BOB D. CAMPBELL & CO., INC.

TRANSMITTAL LETTER

RE: Summit Phase 3

DESCRIPTION	REMARKS
Group 1 Truss Shop Drawings	APPROVED
SHOP DRAWING STAMP COMMENTARY This review was performed only for general conformance with the design concept of the project and general compliance with the information given in the contract documents. Modifications or comments made on the shop drawings during this review do not relieve the contractor from compliance with the requirements of the plans and specifications. Approval of a specific item does not include approval of the assembly of which the item is a component. Contractor is responsible for: dimensions to be confirmed and coordinated at the job site; information that pertains solely to the fabrication process or to the means, methods, techniques, sequences, and procedures of construction; coordination of the work of all trades; and for performing all work in a safe and satisfactory manner. DEFINITIONS APPROVED Submitted materials appear to satisfy design intent if installed using specified materials in a workmanlike manner. Fabrication and construction may proceed. FURNISH AS CORRECTED Submitted materials appeared basically satisfactory, but minor

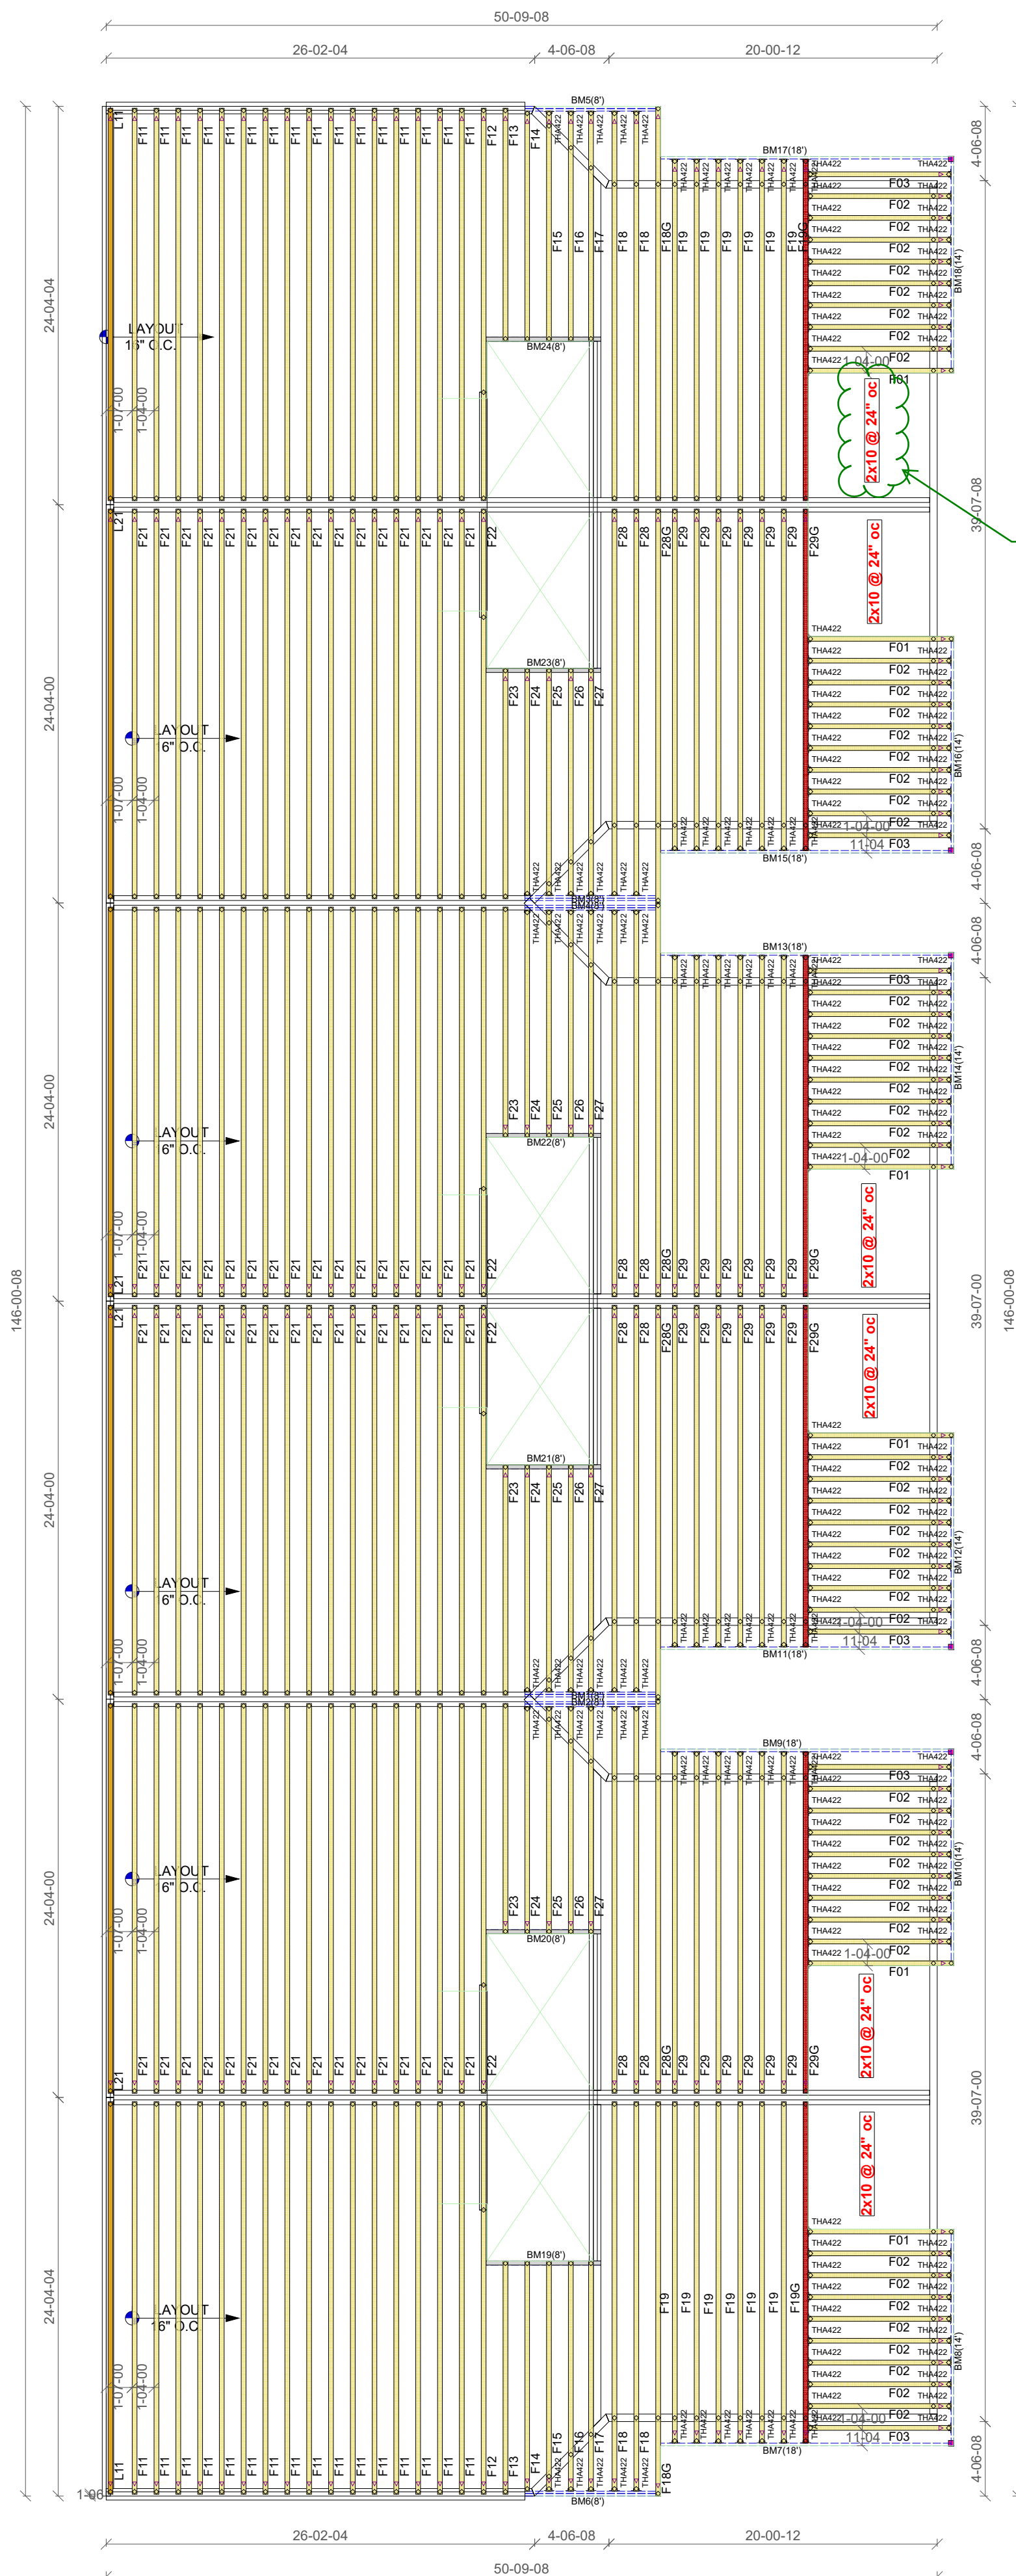
Verify Correct callout, structural calls 16" O.C. for this unit and 24" O.C. for the others
